Application for Works Approval

Works Approval Number W2961/2025/1

Applicant Aragon Resources Pty Ltd

Premises Fortnum Gold Operations
L52/172, M52/5, M52/6, M52/95, M52/96, M52/98, M52/99,
M52/125, M52/132 and M52/133
PEAK HILL WA 6642

Figure 4: TSF2 existing monitoring bores and CPTSF proposed monitoring bore locations

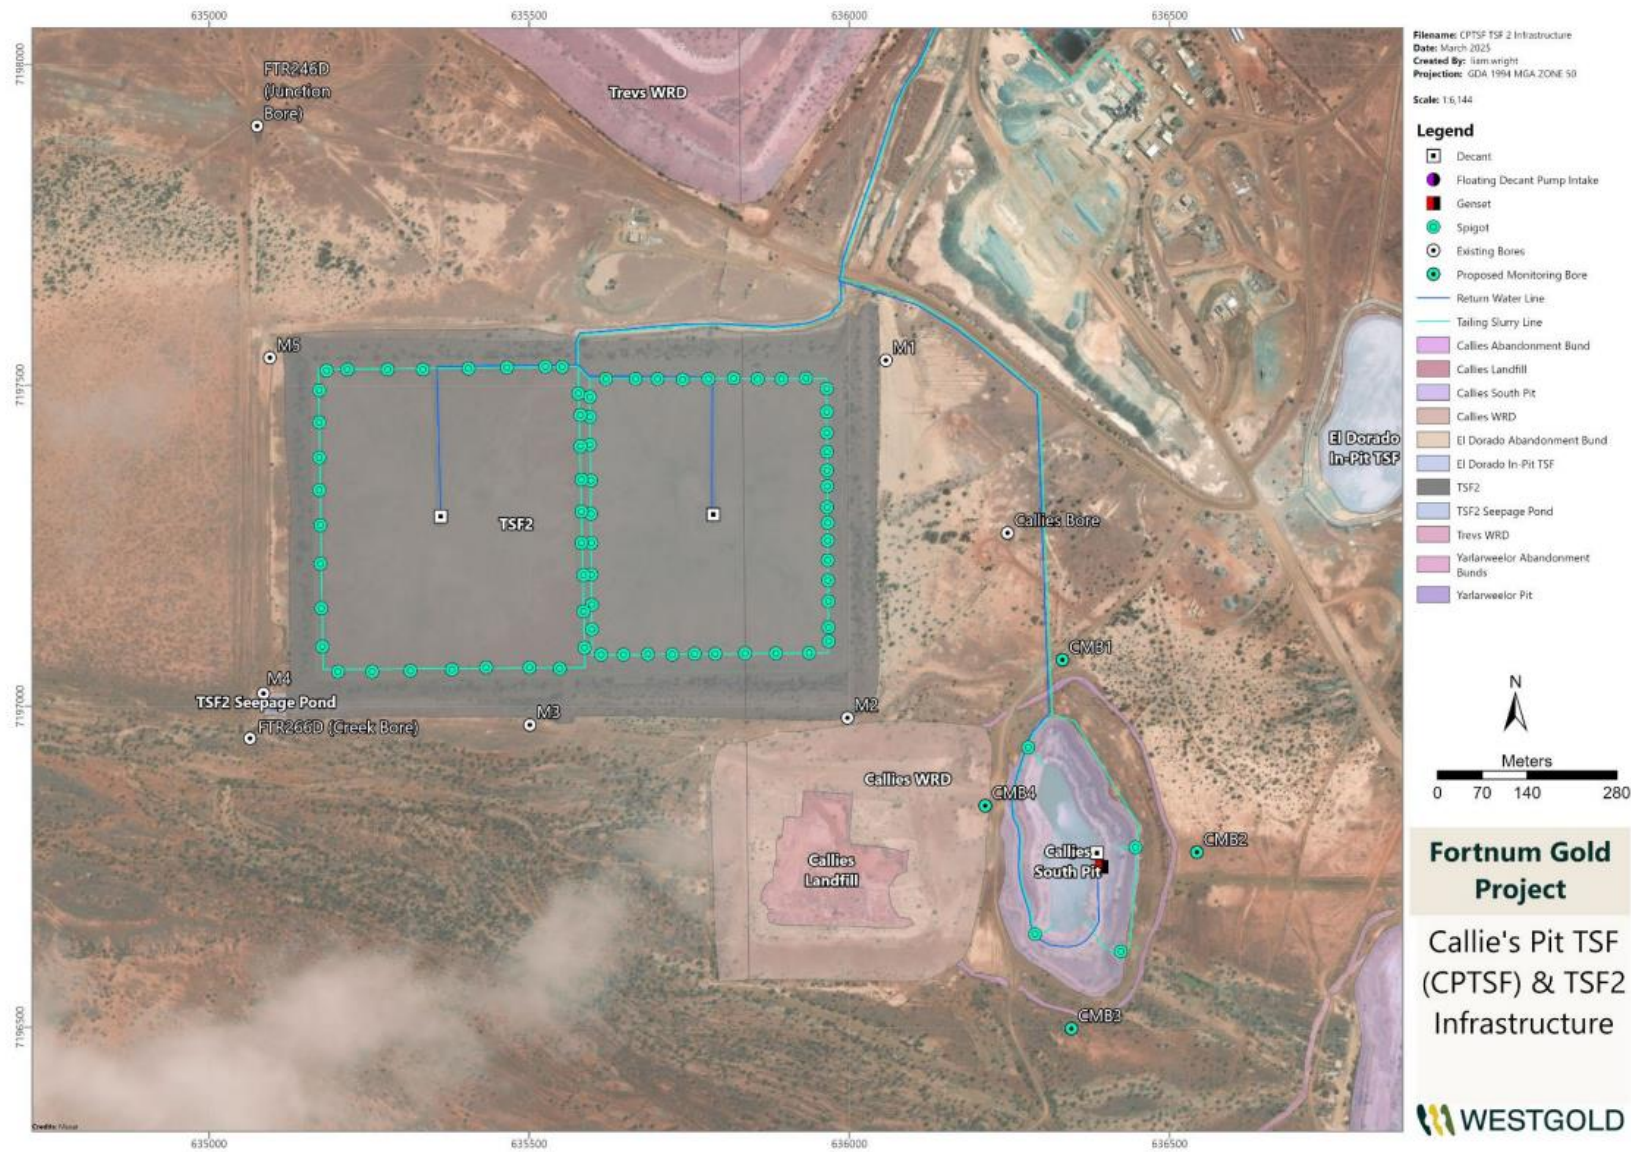
To monitor groundwater level and quality around the CPTSF, the applicant has proposed to install four monitoring bores (CMB1, CMB2, CMB3 and CMB4).

The department has conditioned the construction of the proposed four monitoring bores through condition 2.

Under condition 7 the applicant must within 30 days of the monitoring bores being constructed and **prior to environmental commissioning of the CPTSF** conduct baseline sampling (at least one event) from the four bores (CMB1, CMB2, CMB3 and CMB4) for the parameters outlined in Table 7 of the works approval.
